TOWN PLANNING BOARD

**TPB Paper No. 10260
For Consideration by the
Town Planning Board on 24.3.2017**

**DRAFT NORTH POINT OUTLINE ZONING PLAN NO. S/H8/25
CONSIDERATION OF REPRESENTATIONS NO. TPB/R/S/H8/25-1 TO 442
AND COMMENTS NO. TPB/R/S/H8/25-C1 TO C4**

繪圖
DRAWING
H - 3

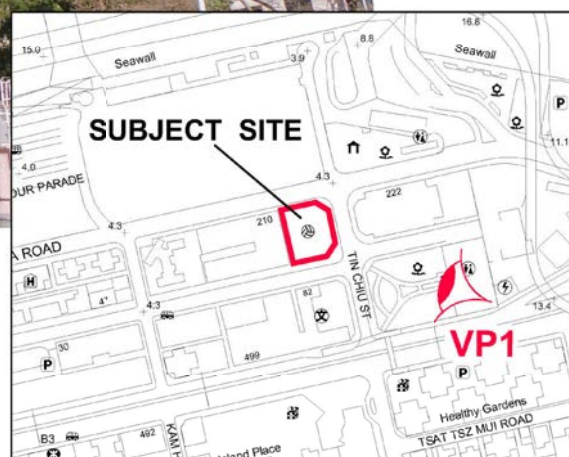
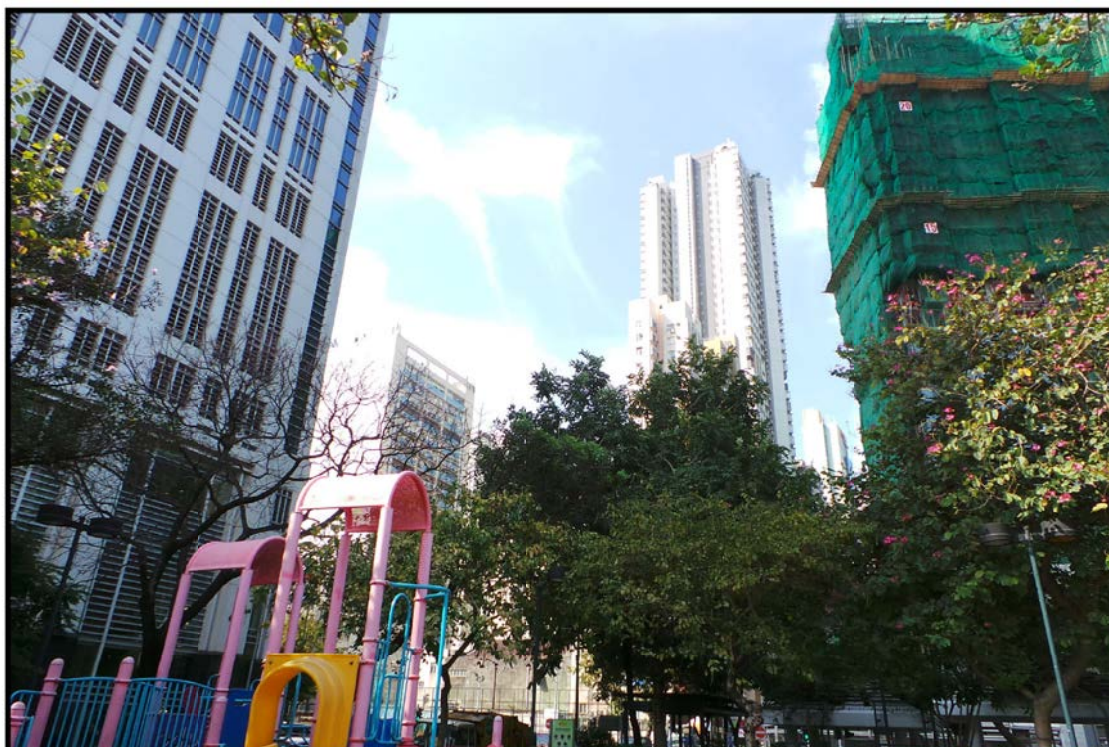
- 4.3.17 The proposed public housing development (110mPD) is taller than the adjacent private development (80mPD). It is excessively tall and incompatible with the surrounding buildings. The proposed development would block the view from the residences nearby and cause adverse visual impact to the local residents.
- 4.3.18 The relaxation of BHR for the site would destroy the beautiful coast of Victoria Harbour. There has been a strong request for restricting the buildings along the waterfront to 100mPD to achieve a stepped BH profile. Developments of more than 20 storeys are opposed. No more tall buildings should be built in the area. Land near the waterfront should only be used for low-rise development e.g. open space, community centre, and cultural/recreational uses.

- 6.3.23 Based on the photomontages (**Drawings H-3 to H-6**) and the visual appraisal conducted by HD, the proposed development will be comparable in scale and height to the surrounding area with predominantly high-rise residential buildings (e.g. Island Lodge) mingled with GIC uses (e.g. CHQ, Chan's Creative School (Hong Kong Island)). The proposed development will not affect views to the ridgelines or Victoria Harbour. Visual effect of the proposed development on medium range and long range is considered negligible. Views from close range will inevitably result in some loss of visual permeability. In overall terms, while the resultant visual impact is slightly adverse, the proposed development will not be incompatible with its surroundings.

Figure 8 Wind Environment under Annual Wind Condition

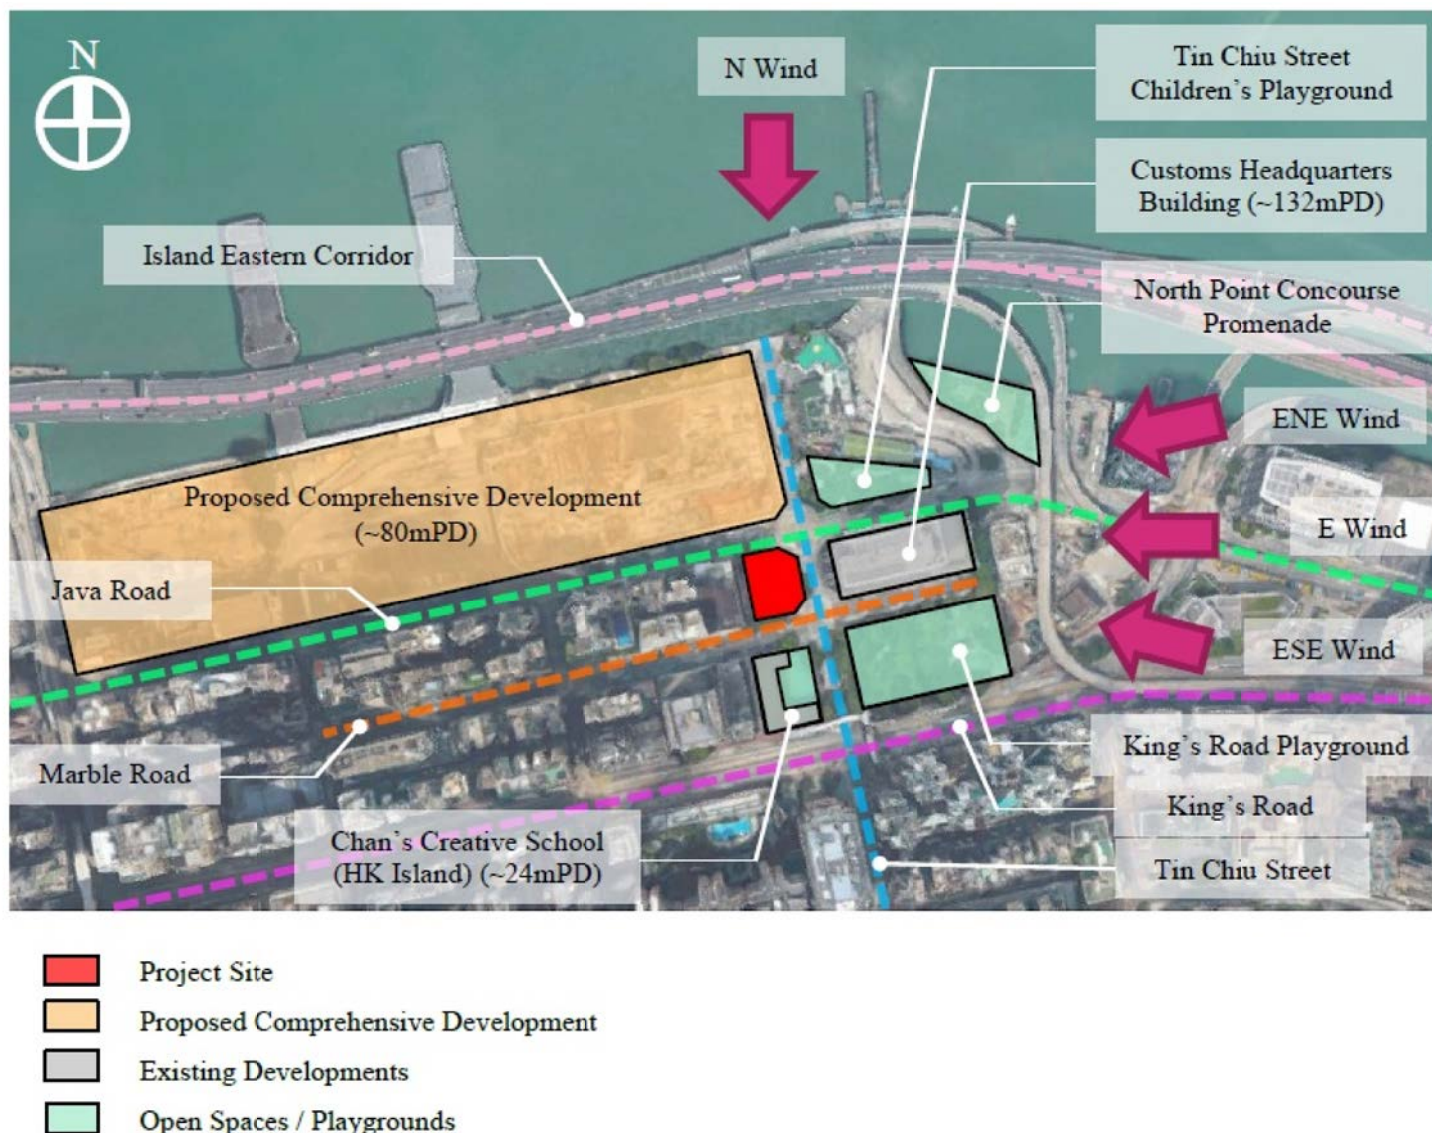
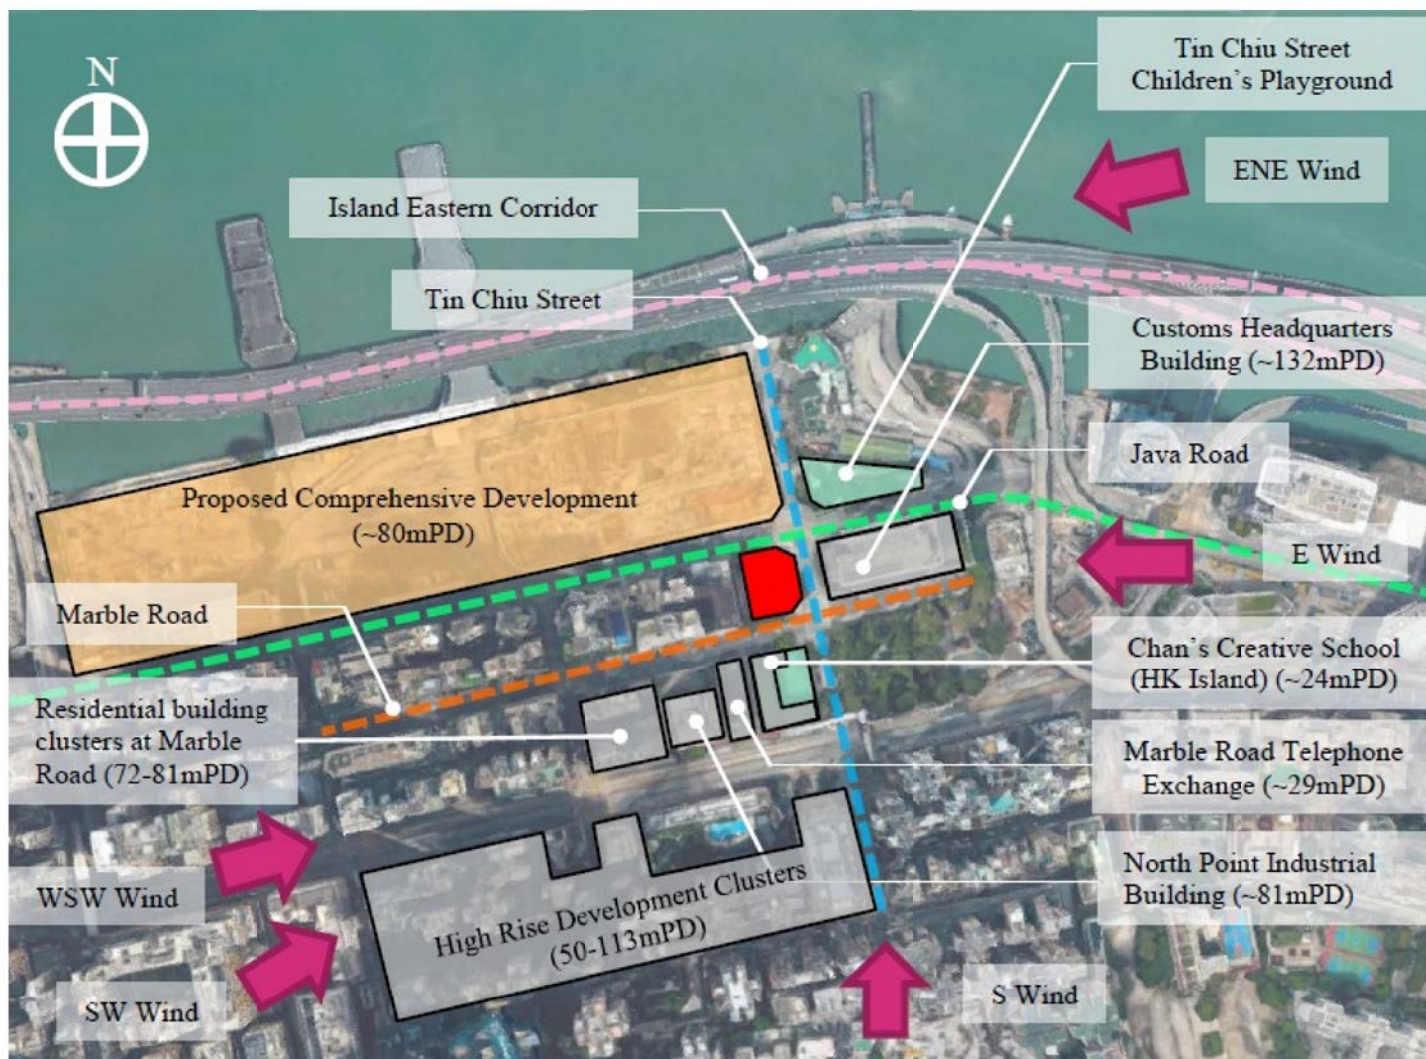
- 4.3.5 The Air Ventilation Assessment (AVA) Expert Evaluation (EE) conducted by HD has concluded that “design measures including corner splays design with setbacks from the site boundary and a ground floor empty bay would facilitate wind flow and alleviate the potential ventilation impact to the surrounding area”. This shows the EE has acknowledged that the proposed residential development will have adverse air ventilation impact to the surrounding area. Since the mitigation measures are not statutory or compulsory, the proposed residential development would cause blockage of ventilation corridor and sunlight penetration to the area.

- 4.3.6 The AVA EE uses the data of a wind tunnel test 8 years ago and does not include detailed calculations and figures. There is no analysis in the AVA EE to feature the recommendations in the Urban Climatic Map published

by PlanD. A comprehensive assessment using updated wind data on the proposal's implication on the surrounding environment, road temperature and dispersion of air pollutants is required.

- 6.3.6 An AVA EE has been carried out by HD to evaluate the wind performance of the site comparing scenarios under an OZP compliant scheme and the proposed public housing development in a qualitative way. According to the AVA EE, the annual wind directions are from N, ENE, E and ESE, while summer winds are from ENE, E, S, SW and WSW (**Drawings H-7 and H-8**). Under the N and S wind directions, the prevailing winds mainly flow along Tin Chiu Street. For ENE, E, SW, and WSW wind conditions, the prevailing winds would mainly flow along Marble Road and Java Road; while under ESE wind, the wind would flow along Marble Road. Although the proposed development would induce some localised impact at part of Java Road, Marble Road and Tin Chiu Street, the representation site is situated at the end of a street block and bounded by roads on three sides with a configuration facilitating provision of splayed street corners (**Drawing H-1**). The proposed design measures including a 2m setback from site boundary at the two splayed corners and provision of a ground floor empty bay of 3.5m (width) x 3m (height) abutting Tin Chiu Street could facilitate air flow. They could achieve the effect of reducing ground coverage, increasing building permeability and maintaining connectivity of air path as proposed under the "Urban

Climatic Map and Standards for Wind Environment – Feasibility Study” for improving urban climate. With these measures, the proposed development is not anticipated to have significant adverse air ventilation impact on the overall surrounding pedestrian wind environment as compared with the OZP compliant scheme.

- 6.3.8 Regarding the wind data, the AVA EE for the proposed public housing development has considered three sets of wind data: (1) the wind availability of the development site from a wind tunnel experiment previously conducted in 2008 for the “Final Report for An Instructed project at the Ex-NPE Site, North Point, Hong Kong” by the CLP Power Wind/Wave Tunnel Facility at The Hong Kong University of Science and Technology; and (2) the mathematical models – RAMS from PlanD, and (3) the closest weather station – North Point Weather Station from the Hong Kong Observatory. The latest RAMS data have taken into account topography and building morphology in the area. As advised by the Chief Town Planner/Urban Design and Landscape (CTP/UD&L), the wind data adopted in the AVA EE are considered appropriate in determining the annual and summer prevailing winds available to the project site and in line with the general approach of conducting an AVA EE.

H - 1b

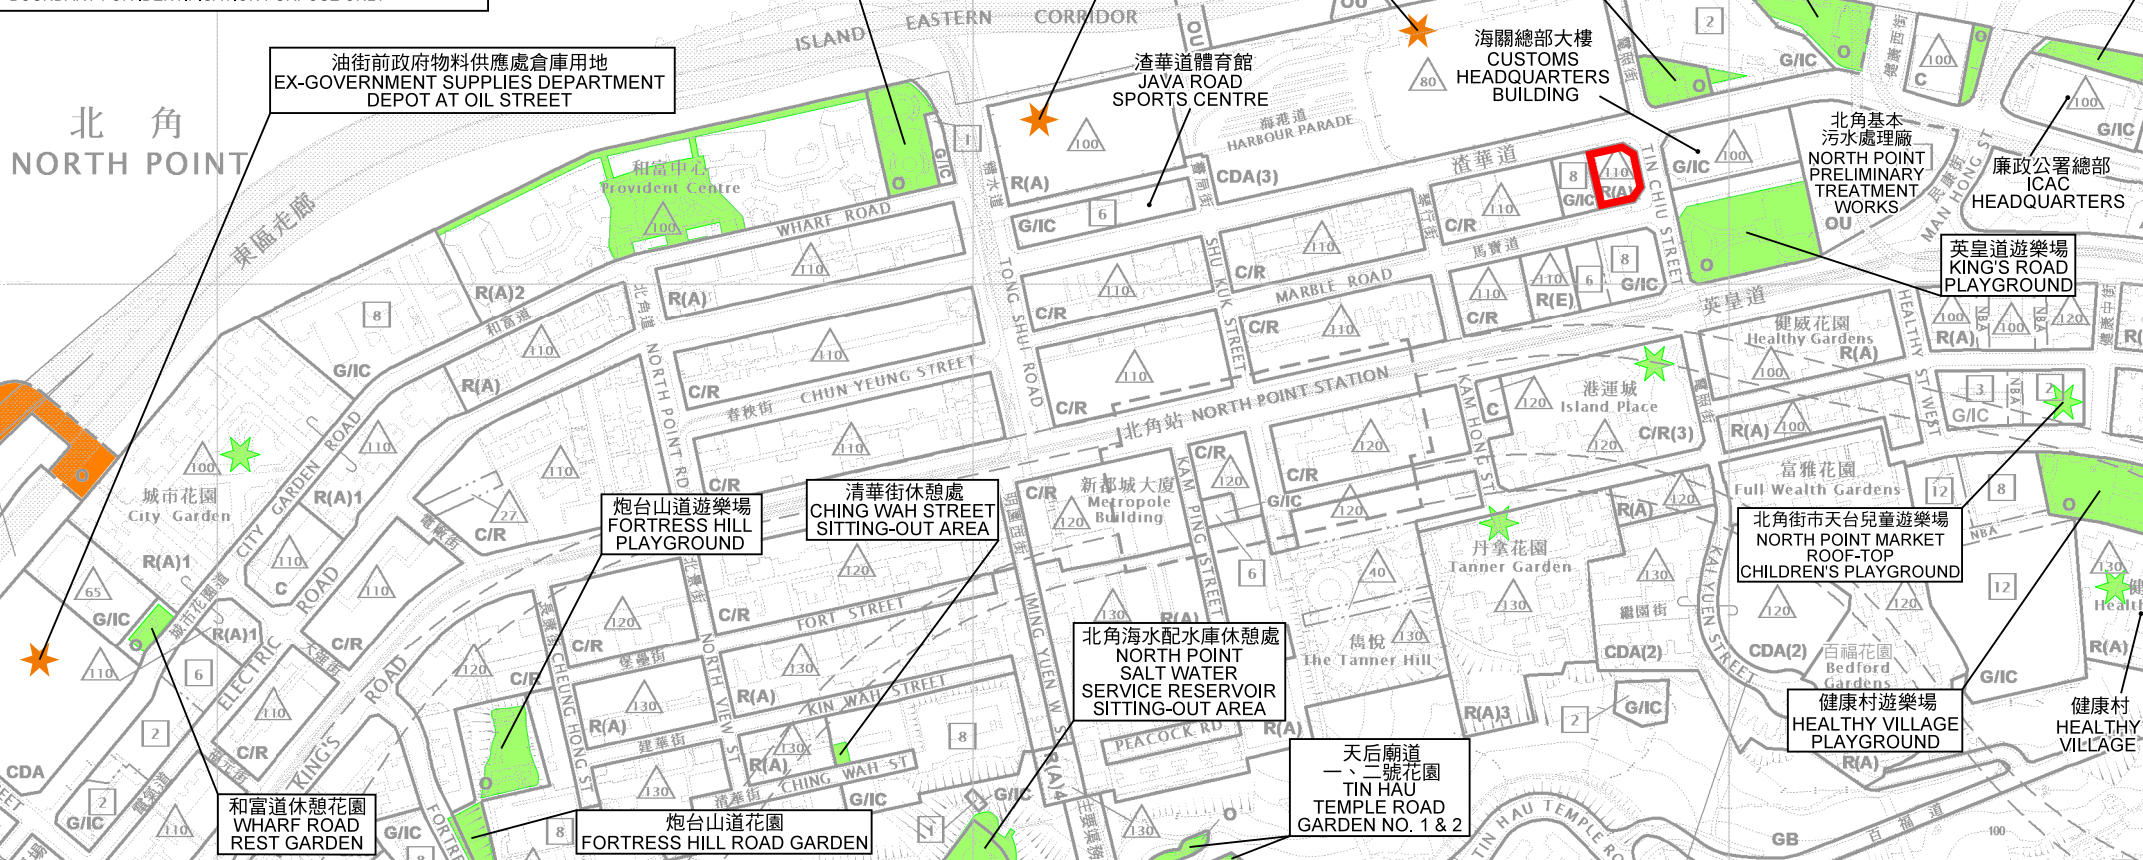
- 4.3.7 Schools, residential developments and North Point Welfare Association Chan Shu Kui Hall are located nearby. The proposed public housing development would bring adverse air, noise and other pollution impacts.
- 4.3.8 Possible air pollution generated from the nearby sewerage treatment plant will threaten the health of residents. This should be assessed.

- 6.3.10 Regarding the concern on the possible air pollution from the North Point Preliminary Treatment Works, the representation site is more than 100m from the facility (**Plan H-1b**). According to the Environmental Impact Assessment study for the HATS Stage 2A project, with mitigation measures implemented, e.g. deodorisation system, the predicted odour levels at the representation site would be 1-2 odour units (OU), which is within the acceptable criterion (i.e. 5OU). Objectionable odour is also controlled under APCO.

- 6.3.12 There is neither designated GIC use for the representation site nor request from the relevant government departments to use the site for standalone GIC facilities. The provision of major community facilities for the planning scheme area of North Point OZP has also been duly assessed (**Annex V**). Although there is shortfall of one sports centre, provision of recreational and sports facilities shall be considered by LCSD taking into account various factors including the demand for such facilities, usage of existing facilities, HKPSG, resources availability as well as views of the relevant district council. It should be noted that the representation site is too small (0.12 ha) to accommodate a standard sports centre (0.6 ha) and there is already a sports centre located nearby (i.e. Java Road Sports Centre) (**Plan H-1b**).

- 6.3.14 For the representers' concern on the loss of open space due to government developments, it should be noted that the CHQ site at Tin Chiu Street has all along been zoned "G/IC" on the OZP and was not intended for open space use, though part of it was once used as a basketball court on a temporary basis. Regarding compensation for the previous soccer pitch on the ICAC HQ site at Man Hong Street, it should be noted that when the said soccer pitch was rezoned from "O" to "G/IC" for the development of ICAC HQ in 2002, a site at Tong Shui Road was rezoned from "G/IC" to "O" for the development of a local open space (i.e. Tong Shui Road Garden) in return. Subsequent efforts have been made to increase the open space provision in the major redevelopment sites in North Point, including incorporating 1.5 ha and 3,530m² of public open space in the planning briefs for the redevelopments at the ex-NPE site and the ex-Government Supplies Department Depot at Oil Street respectively (**Plan H-1b**).
